**Oyster Creek  
License Renewal Project  
Drywell Monitoring Program**

**Information for ACRS Subcommittee**

Subject: Response to NRC Request for Additional Information, dated March 10, 2006,  
Related to Oyster Creek Generating Station License Renewal Application (TAC  
No. MC7624)

**Response to 3/10/06 Request for Additional Information  
Oyster Creek Generating Station  
License Renewal Application (TAC No. MC7624)**

**Fig. – 3 Corrosion Trend in Sand Bed Region Bay with highest Drywell Shell Wall Thinning**

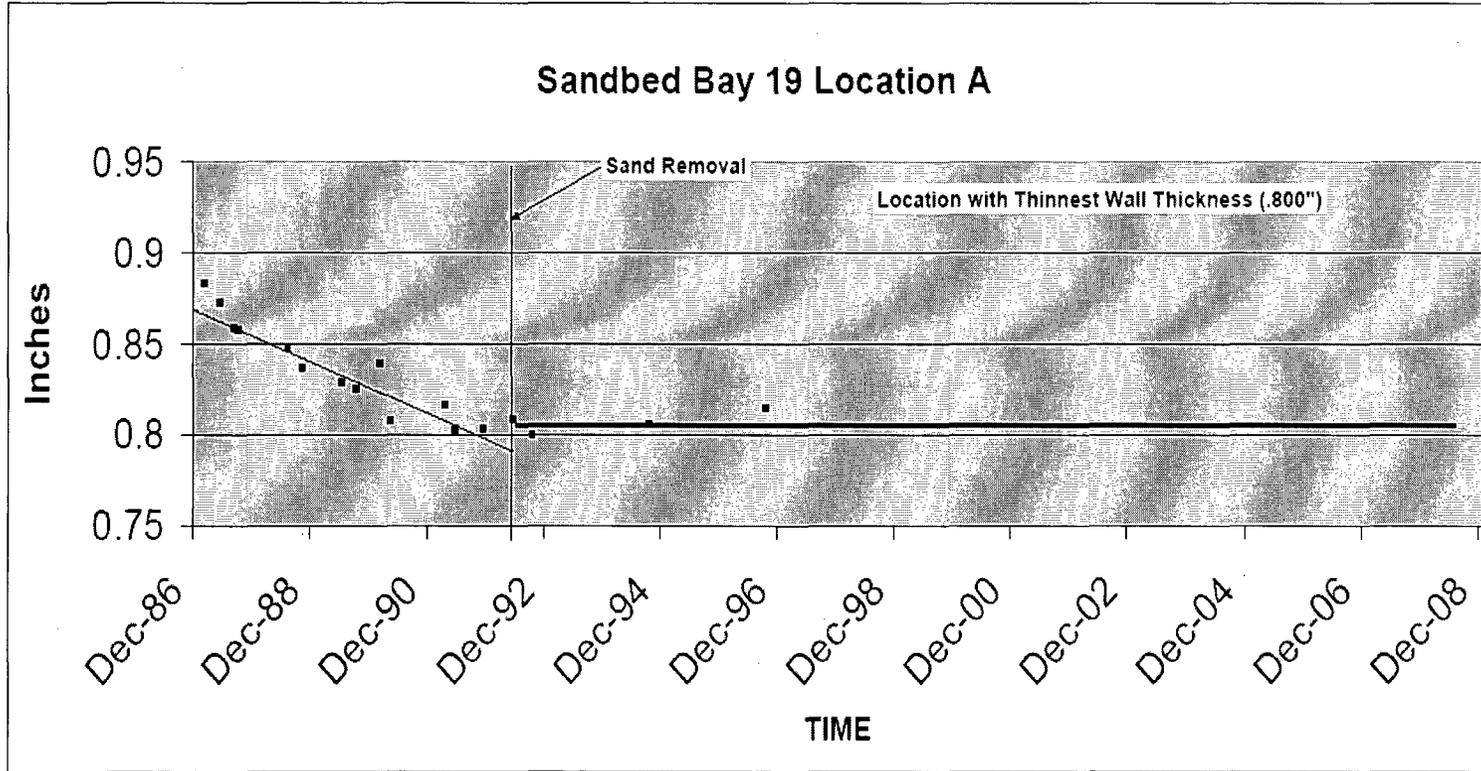
- (d) The following tables provide historical UT thickness measurements, the minimum required thickness, and the nominal thickness of the drywell shell.

**Figure 2 - Drywell to Reactor Cavity Seal Detail**

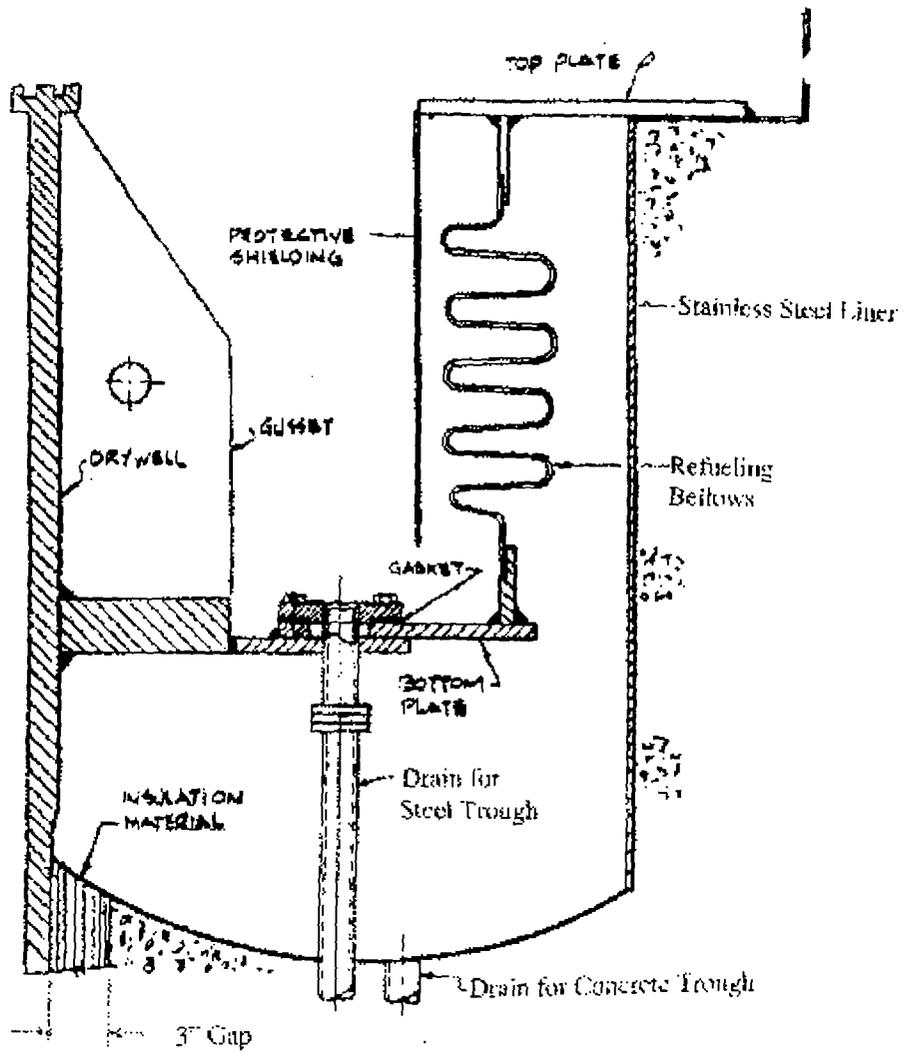
**Leakage from the refueling seal has been identified as one of the reasons for accumulation of water and contamination of the sand-pocket area. The refueling water passes through the gap between the shield concrete and the drywell shell in the long length of inaccessible areas. As there is a potential for corrosion in this area, Subsection IWE of the ASME code would require augmented inspection of this area. The applicant is requested to provide a summary of inspections performed (visual and NDE) and mitigating actions taken to prevent water leaks from the refueling seal components.**

Oyster Creek is currently committed to monitor the sand bed region drains for water leakage. A review of plant documentation did not provide objective evidence that the commitment has been implemented since 1998. Issue Report #348545 was issued in accordance with Oyster Creek corrective action process to document the lapse in implementing the commitment and to reinforce strict compliance with commitment implementation in the future, including during the period of extended operation.
